State of California – Natural Resources Agency  
DEPARTMENT OF FISH AND WILDLIFE  
Inland Deserts Region  
3602 Inland Empire Boulevard, Suite C-220  
Ontario, CA 91764  
[www.wildlife.ca.gov](http://www.wildlife.ca.gov)

October 10, 2024  
*Sent via email*

**Comments on the Notice of Determination for an Addendum to the 1991 Environmental Impact Report: Water from the Owens Valley to Supply the Second Los Angeles Aqueduct 1970 to 1990, 1990 Onward, Pursuant to a Long-Term Groundwater Management Plan for Replacement of Wells W247 and W379 (Project), SCH# 1989080705, and Notice of Exemption**

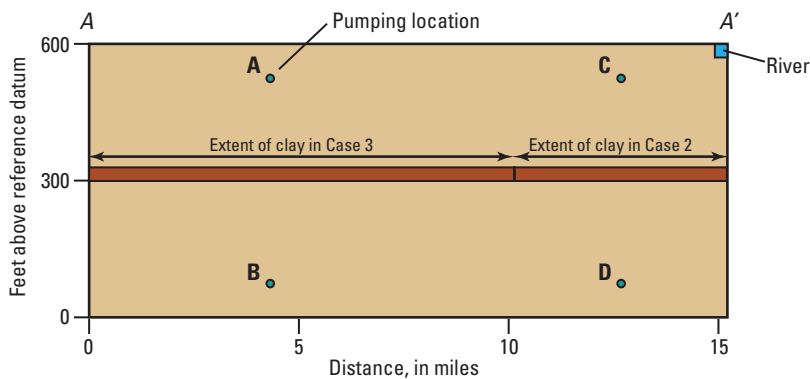
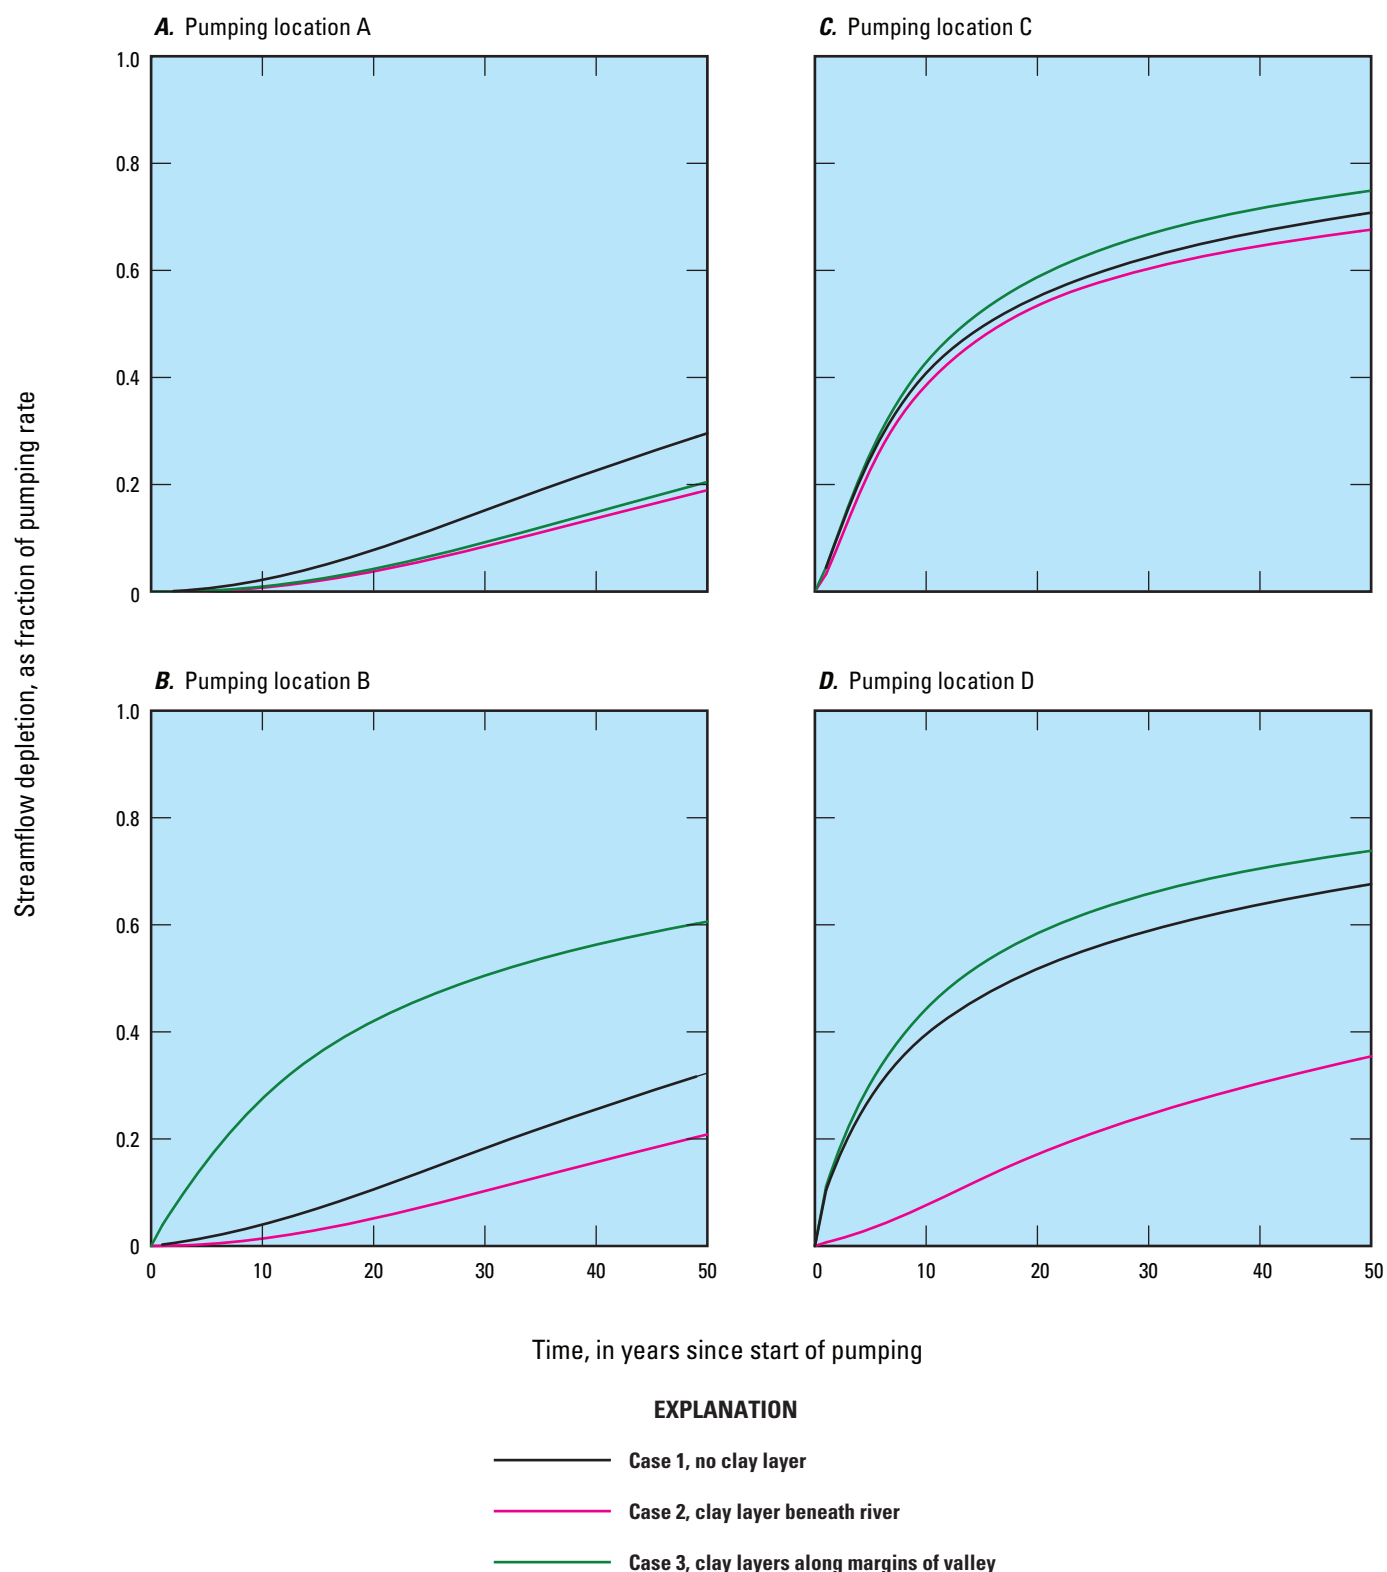
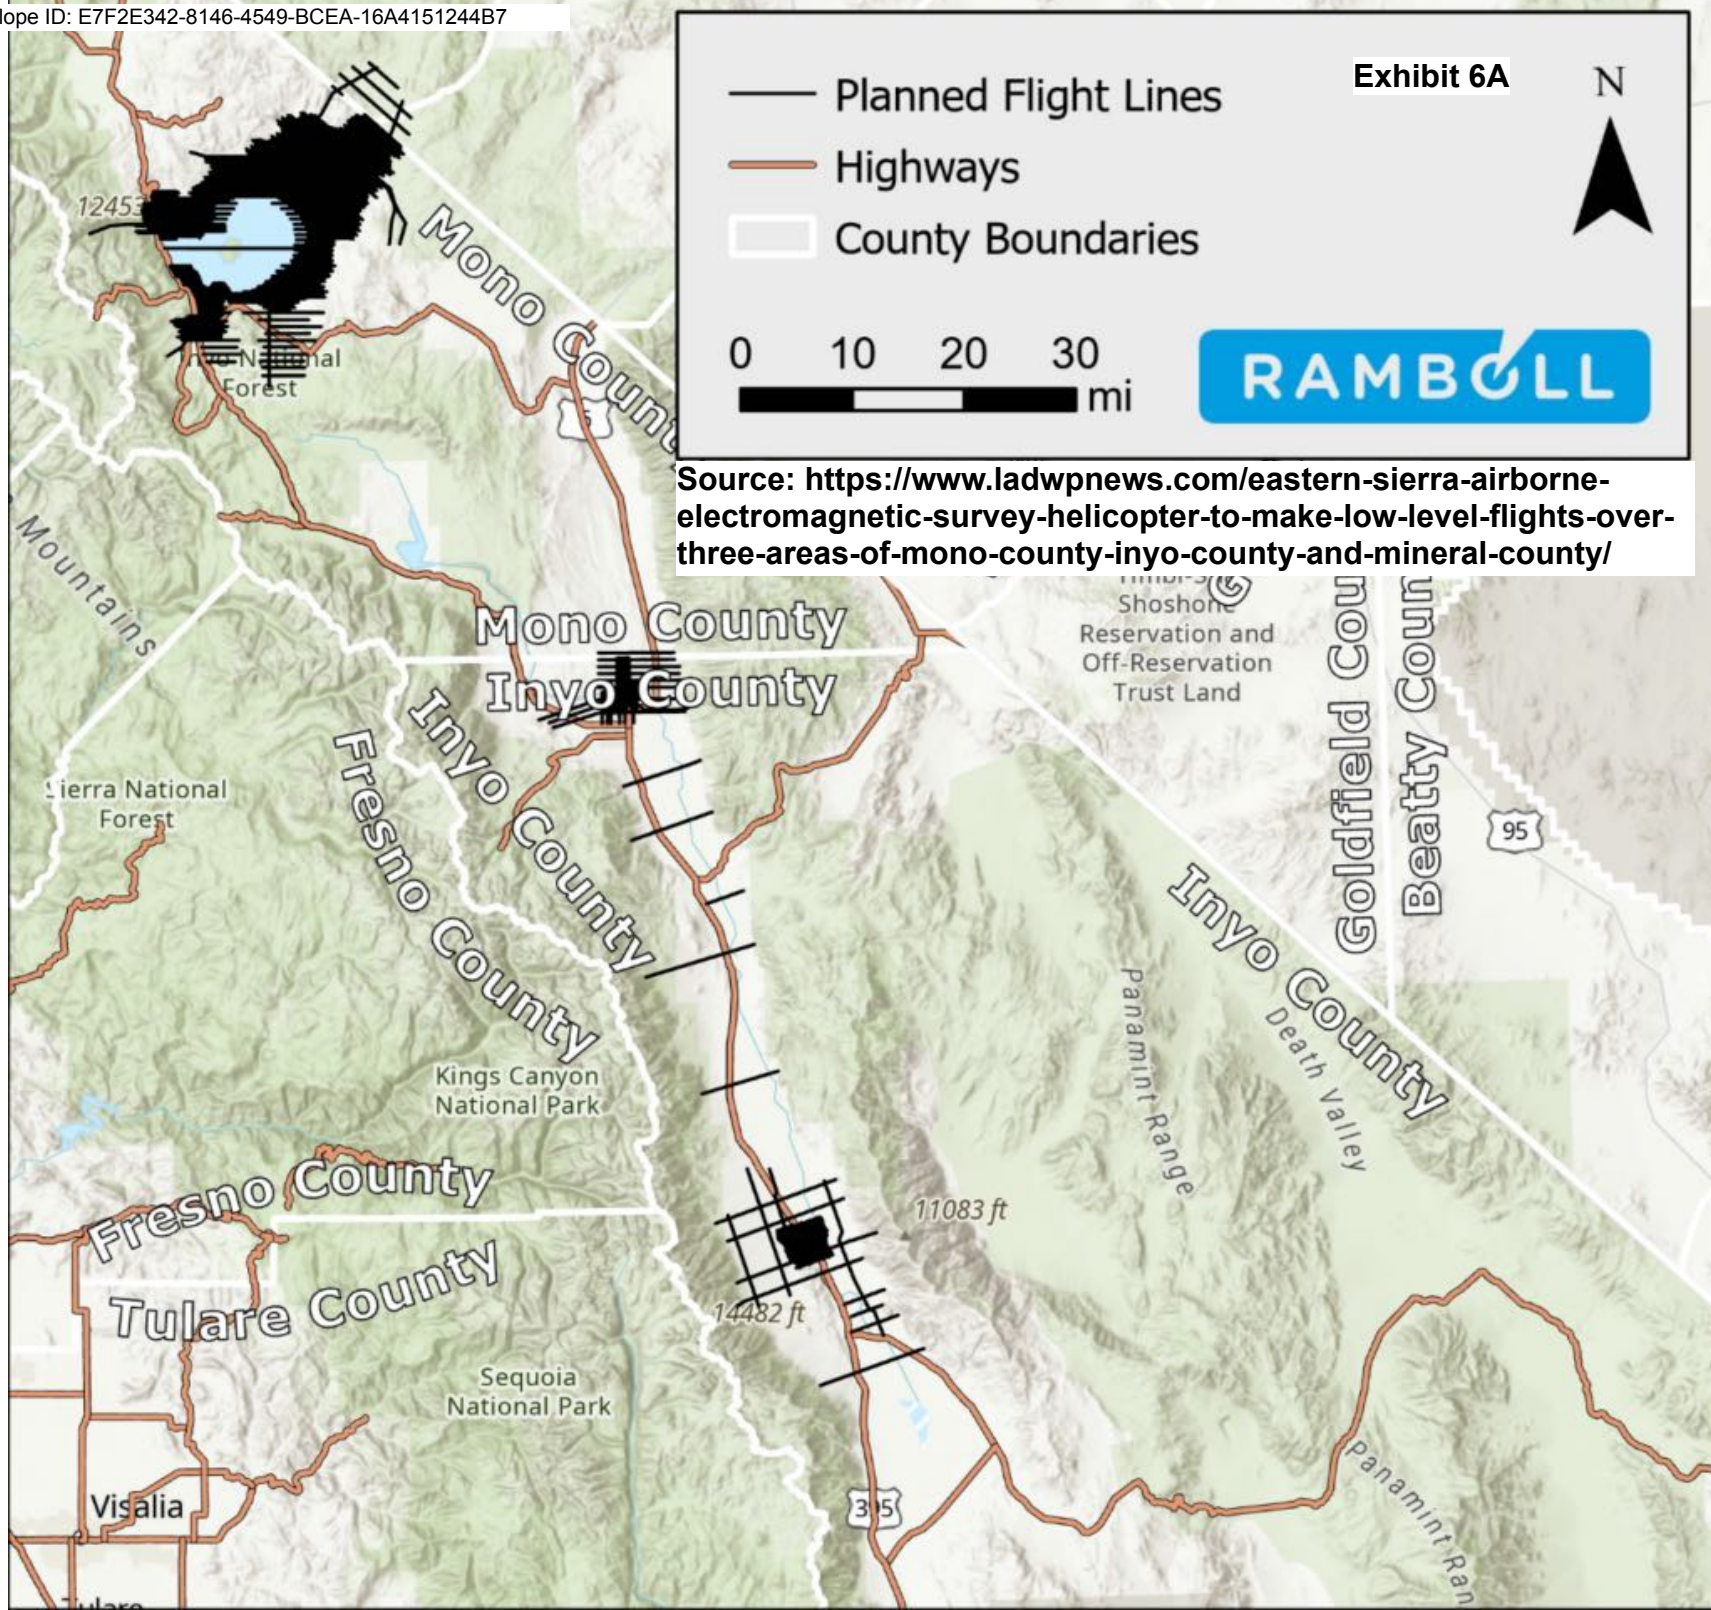
In the U.S. Geological Survey Circular 1376 (Barlow and Leake, 2012), Barlow and Leake modeled the relative impacts of pumping beneath a continuous and non-continuous confining layer versus no confining layer. Exhibits 5A through 5D, taken from Circular 1376, present the findings from the model simulations. The study found that pumping beneath the non-continuous confining layer can produce increased depletion of surface waters not underlain by the confining layer compared to pumping with a continuous confining layer or without any confining layer, i.e., an unconfined aquifer. This increase occurs because the vertical hydraulic conductivity of the confining layer is much lower than the horizontal hydraulic conductivity of the pumped aquifer. As a result, drawdown from pumping below the non-continuous confining layer can propagate more easily laterally towards the river than to the overlying shallow aquifer. The model simulation Case 3 shows the rate of depletion of surface waters increases when the confining clay layers only partially cover the area; see Case 3 versus Cases 1 and 2 in Figure 37B of Exhibit 5D.

## Exhibit 6B

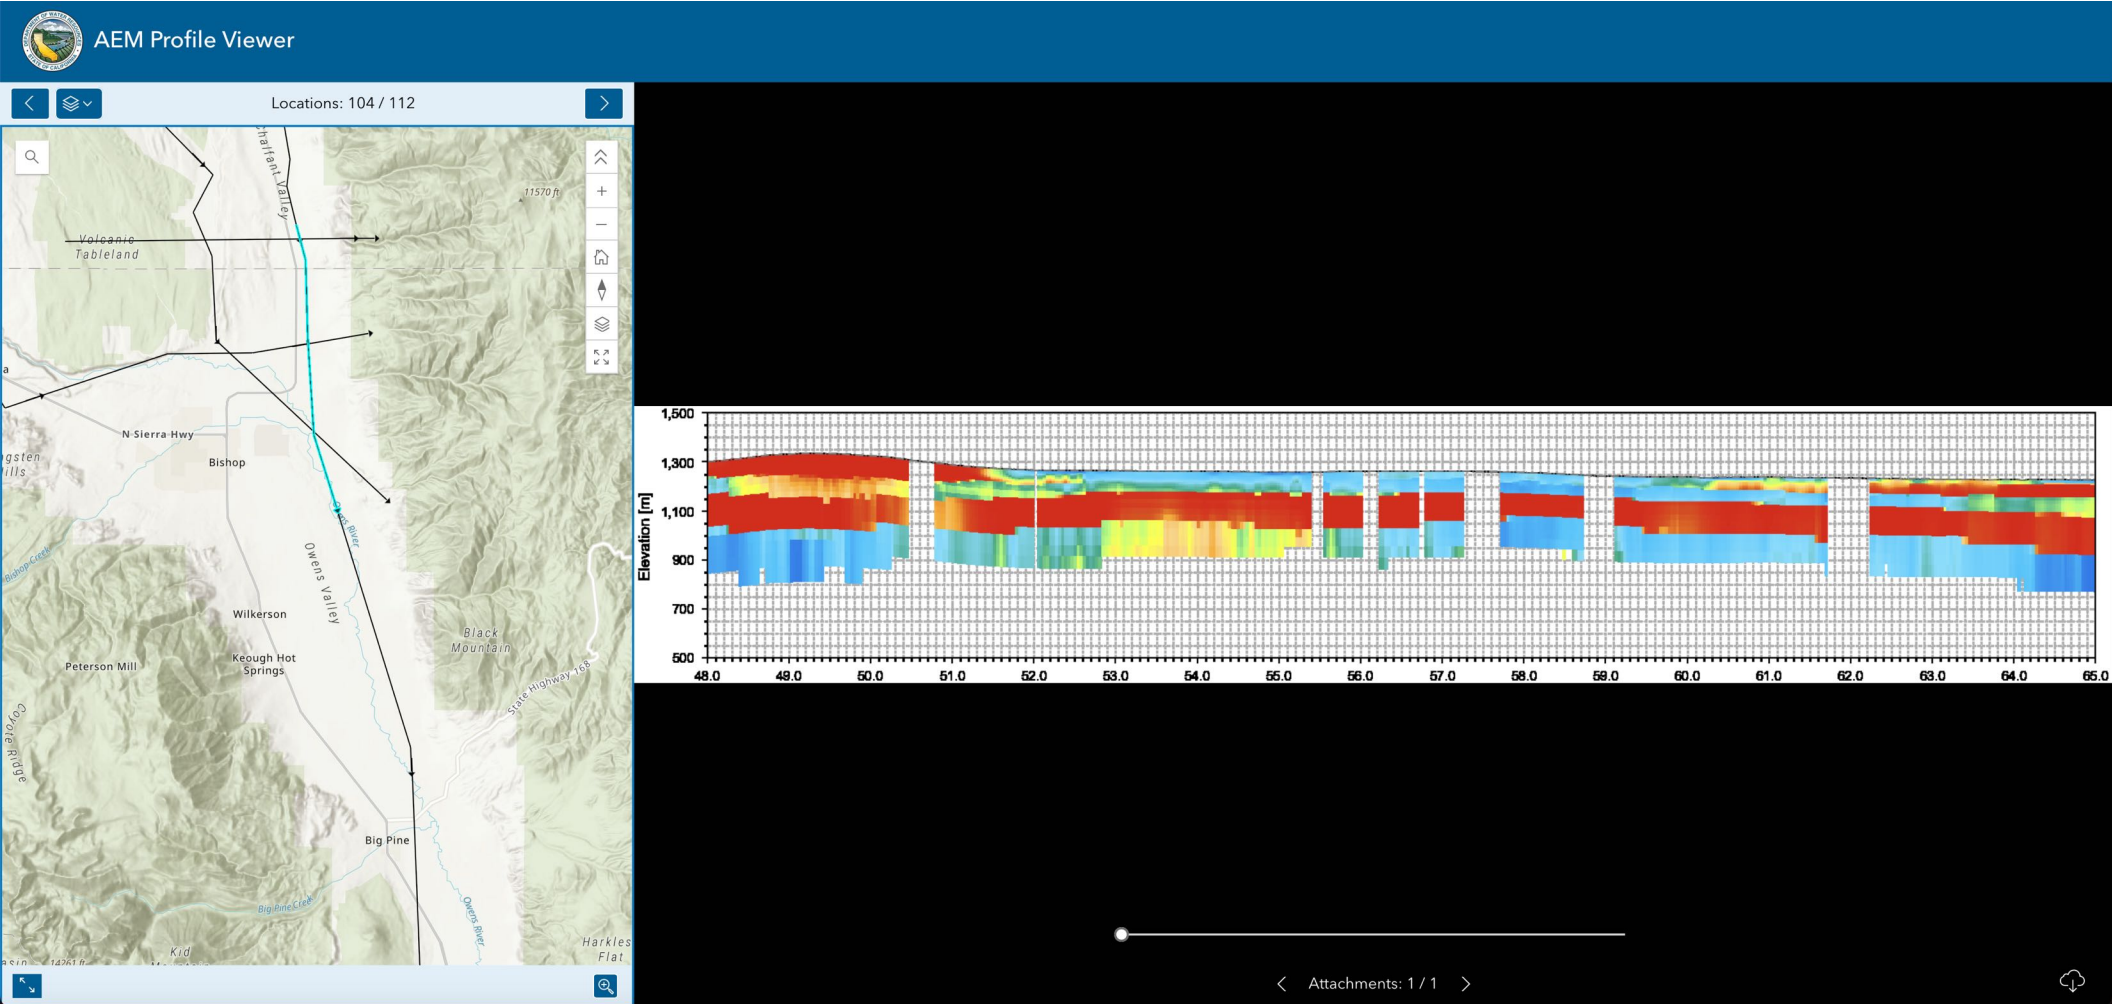
Recent airborne electromagnetics (AEM) surveys by LADWP and Department of Water Resources (DWR), as shown in the attached Exhibit 6A (LADWP, 2024e), and Exhibits 6B through 6F (California Department of Water Resources, 2024) over the Laws Wellfield and Exhibits 6G and 6H for the Big Pine Wellfield. AEM is a geophysical technology that measures the electromagnetic response of the subsurface. AEM data are collected using geophysical instruments on a hoop towed beneath a helicopter. A current is generated in the hoop, which sends an electromagnetic signal into the subsurface to measure natural variations in the electrical properties of soil, rocks, and water. The AEM survey results can be used in conjunction with wellbore data to map hydrogeologic subsurface conditions. The DWR has made the AEM data publicly available on the web (DWR, AEM 3D Viewer (Beta) and AEM Profile Viewer), Exhibits 6B through 6H. LADWP has not publicly released its data set as of the date of this letter.

CDFW recommends that the AEM data and any new borehole data be used to delineate the depth, thickness, and lateral extent of the semi-confining layer(s) and aquifers in the Laws and Big Pine Wellfields. Using this additional data, monitoring well locations and depths can be selected to assess the impacts of pumping these two proposed new wells and the cumulative impacts of pumping the existing production wells in the surrounding areas.
